REGIONAL REVIEW FINDING

ARC REVIEW CODE: R15052201

Name of Proposal: Abernathy Road/Glenridge Drive Development

SUBJECT: **Transportation Division Review of DRI # 2494**

EXHIBIT B

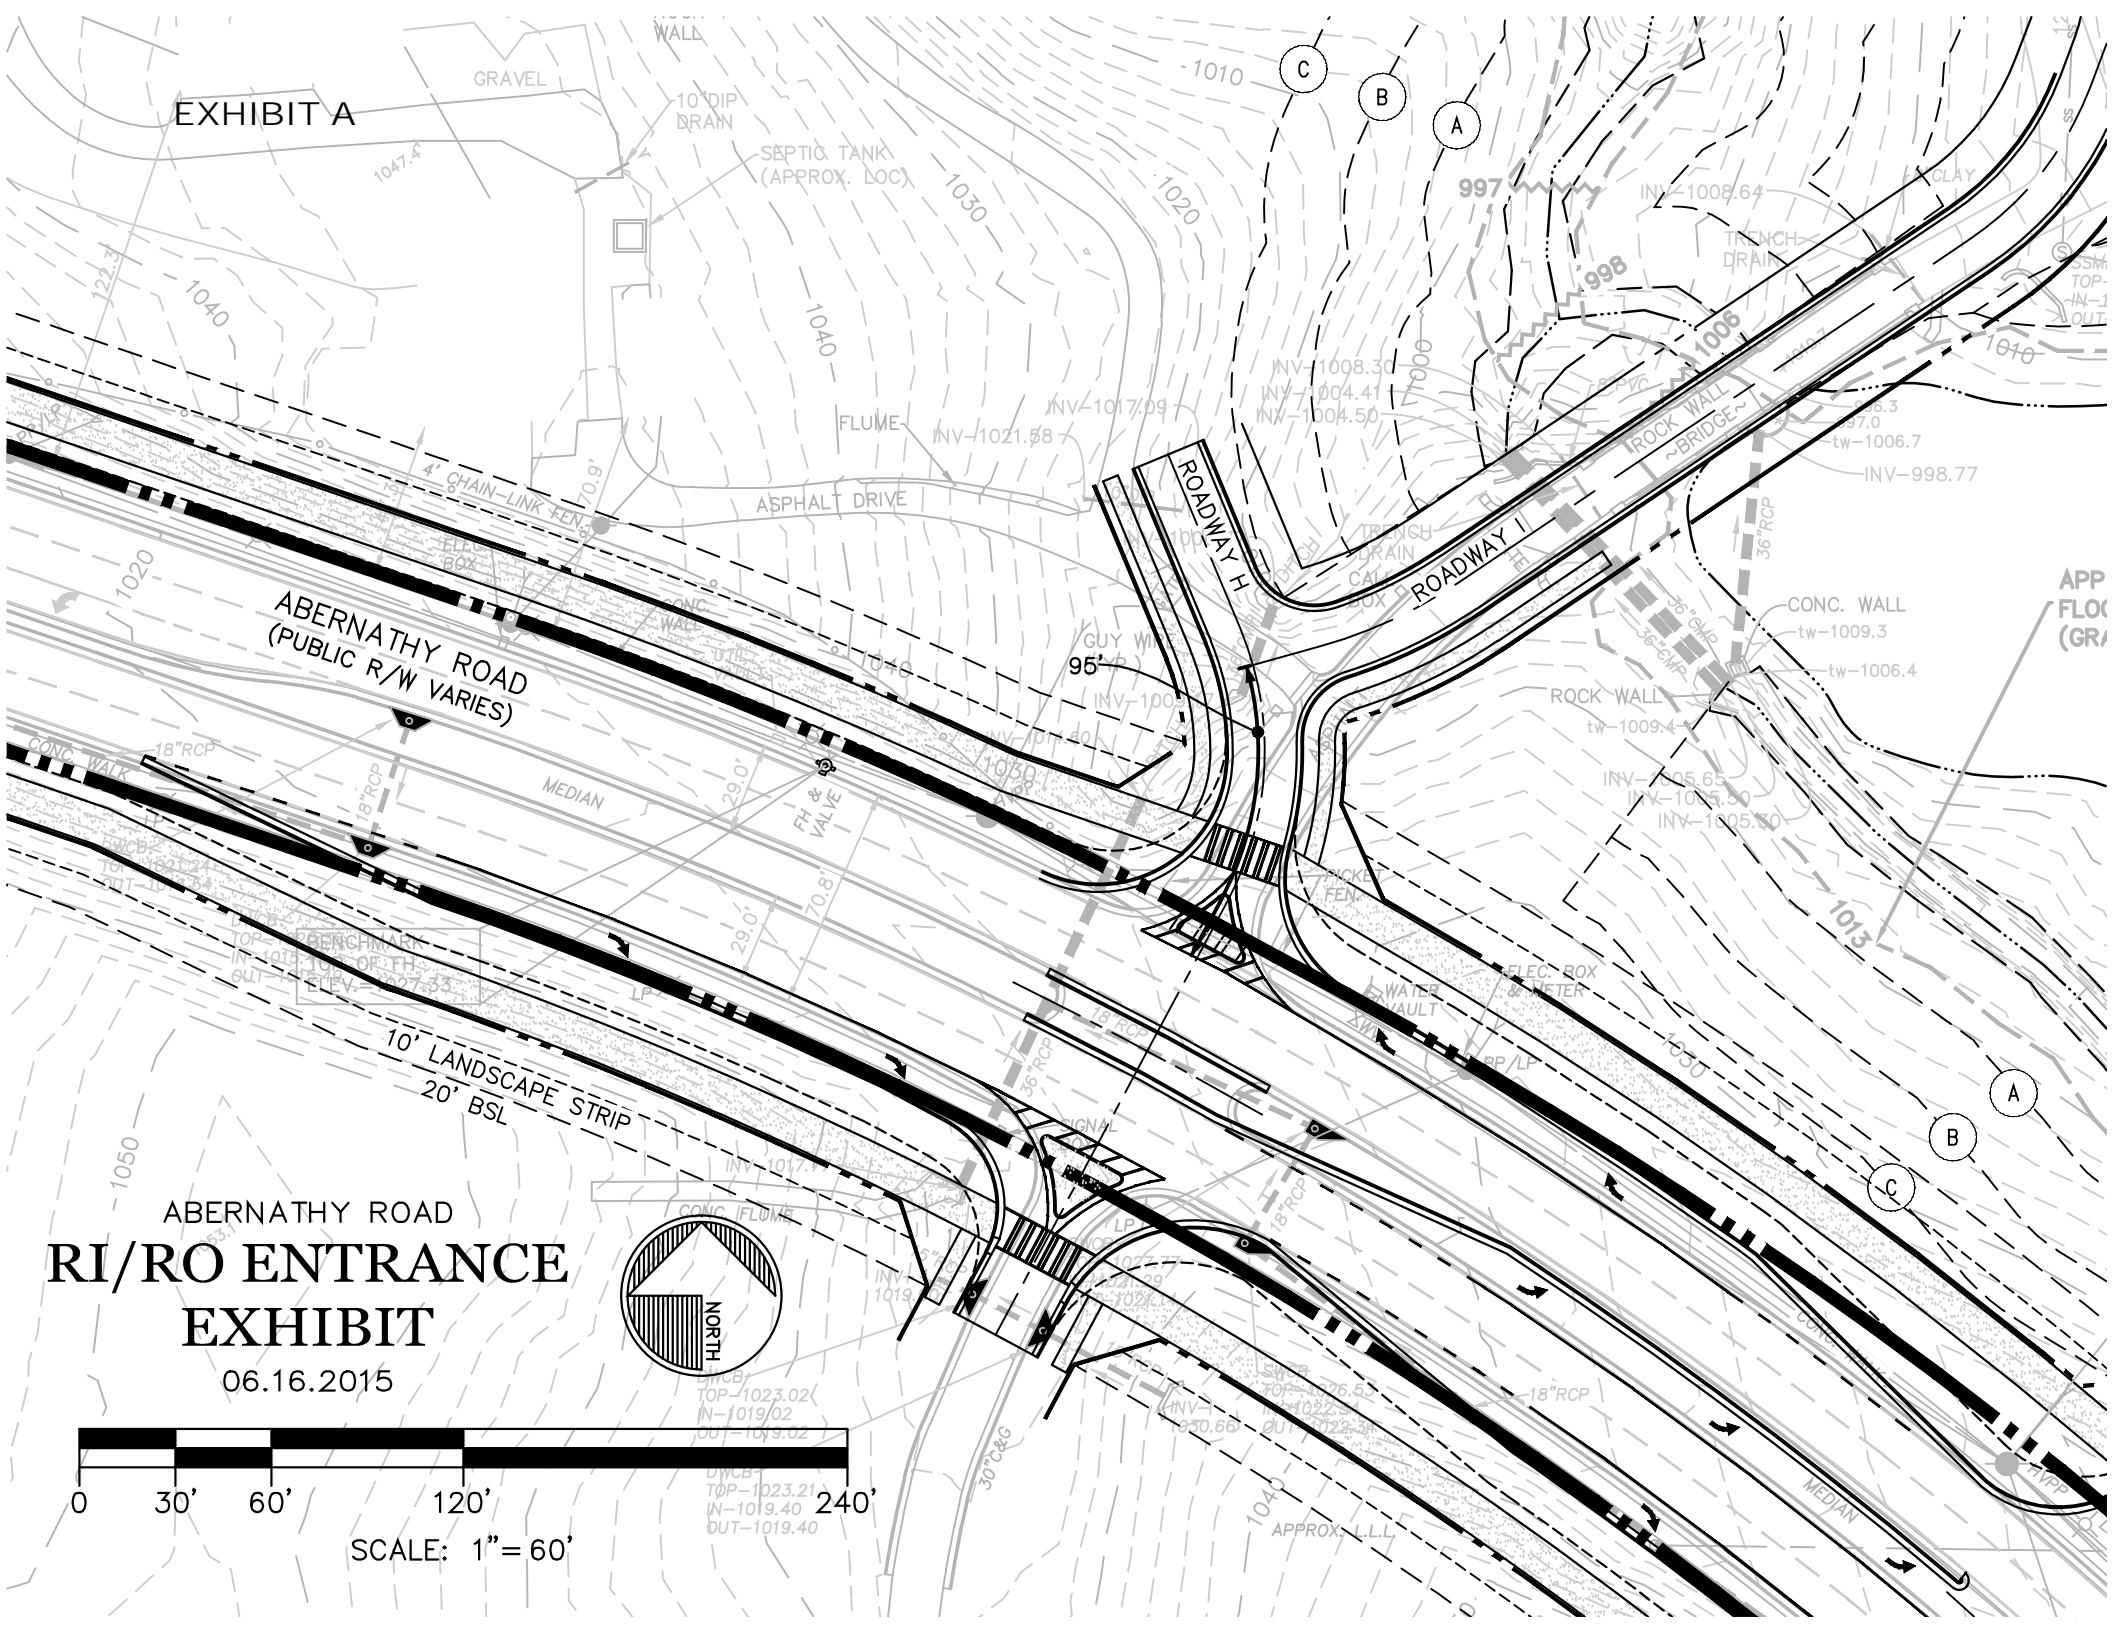
Attached to this letter as Exhibit "A" is an engineered section of the updated intersection at Driveway 1 on the DRI site plan. This section reflects a minimum distance of 95 feet to accommodate the existing stream buffer. We request that this condition be modified to allow this distance in this location or provide that the 100' requirement may be reduced due to stream buffer constraints.

DRI # 2494
PROJECT NAME: 6615 & 6565 GLENRIDGE DRIVE

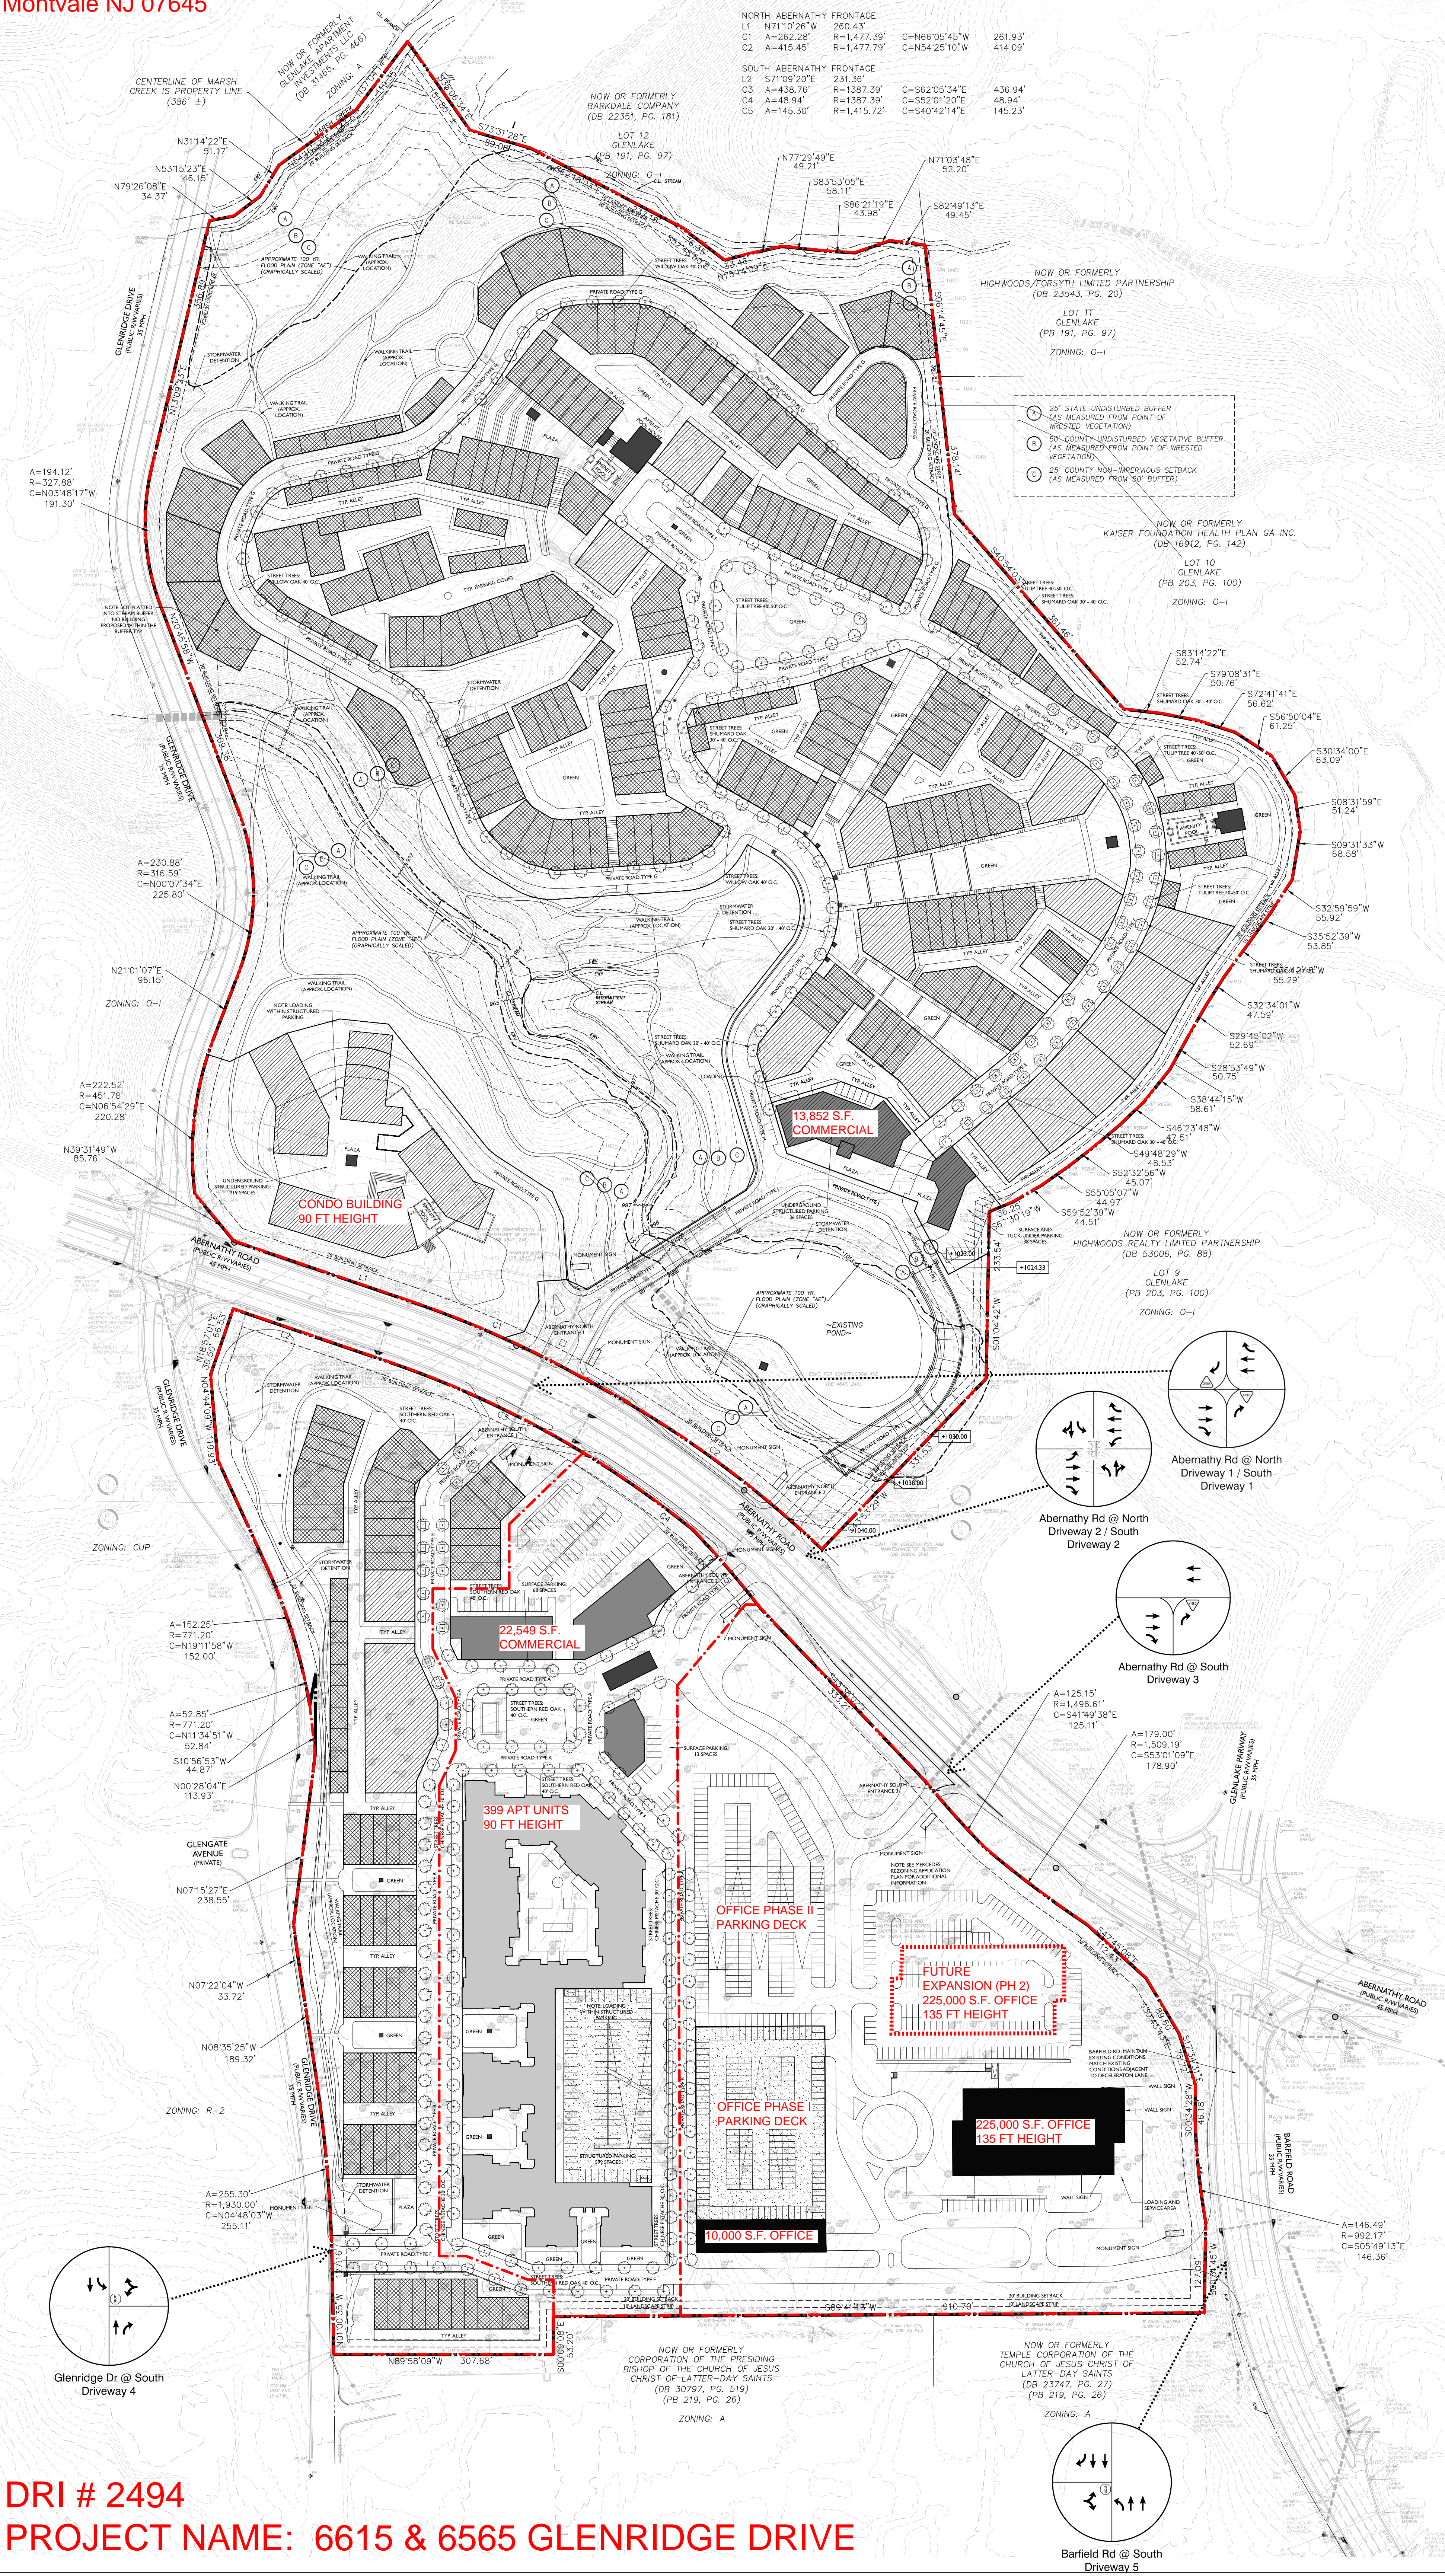
During the pre-review meeting for this DRI, adding an additional access point to the north site from Glenridge Drive was discussed. The developer's consultant identified topography as a potential limiting factor to prevent this access point. Upon review of the traffic study and site plan:

- The site plan includes topo, which shows that Glenridge Drive changes elevation at a comparable grade to the adjacent west side of the site.

- The site plan shows a walking trail connecting from the site to Glenridge Drive at two locations. If two trail connections are feasible with the site's topo, then a roadway connection should also be feasible.

Preserving a location for potential connectivity to the adjacent parcel on the east side of this site was also discussed at the DRI pre-review meeting. It appears that a location for this is shown on the site plan on the northeast edge of the parcel. This location should be clearly labeled as being preserved for future adjacent parcel access.

The site plan identifies the roadways on both sites as private roads. If any roads or parking facilities have gated access, the roadways at the site entrances shall provide adequate queuing space on the approaches to the gates to prevent vehicle queues from extending onto the adjacent roadways.

Bike and pedestrian facilities that will be constructed along adjacent roadways should be clearly identified on the site plan. Additionally, the traffic study states that the City of Sandy Springs “Bicycle, Pedestrian and Trail Implementation Plan” makes a number of recommendations in the vicinity of the site. Recommendations for facilities along public street frontages adjacent to the site should be constructed as a part of the development. The applicant should coordinate with the City of Sandy Springs to ensure implementation of these facilities is consistent with the existing plans.

The submitted site plan shows Marsh Creek, which is a perennial stream on USGS coverage for the project area, forms the northern boundary of the portion of the property on the north side of Abernathy Road (the North Site). The site plan also shows a second stream running through the North Site between an existing pond and Glenridge Drive. The submitted site plan shows the 50-foot undisturbed buffer and additional 25-foot impervious surface setback required under the City of Sandy Springs Stream Buffer Ordinance on both streams (although it is identified as a County buffer on the plans). The State's 25-foot Erosion and Sedimentation buffer is also shown on both streams. However, portions of two proposed structures intrude into the City buffers. If these intrusions remain in the final plans, a variance will be required from the City of Sandy Springs before they can be built in the buffer or setback. Any other state waters that may be identified on the property will also be subject to the State 25-foot Erosion and Sedimentation Act stream buffer.
